Product/Process Change Notice (PCN)

PCN #: WE_PD4_20170616

Product Affected: WE-PD4 size S series

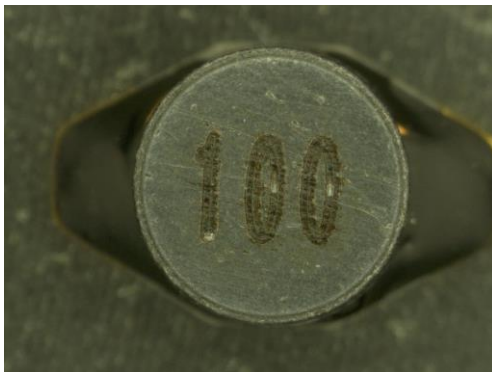
To increase the production capability, the product marking of the WE-PD4 Type S will be changed from Pad printing to Laser Marking.

- 1.) All electrical and mechanical properties of the parts will remain the same.
- 2.) Laser -Marking will be replace the pad printing method.
- 3.) Marking appearance:
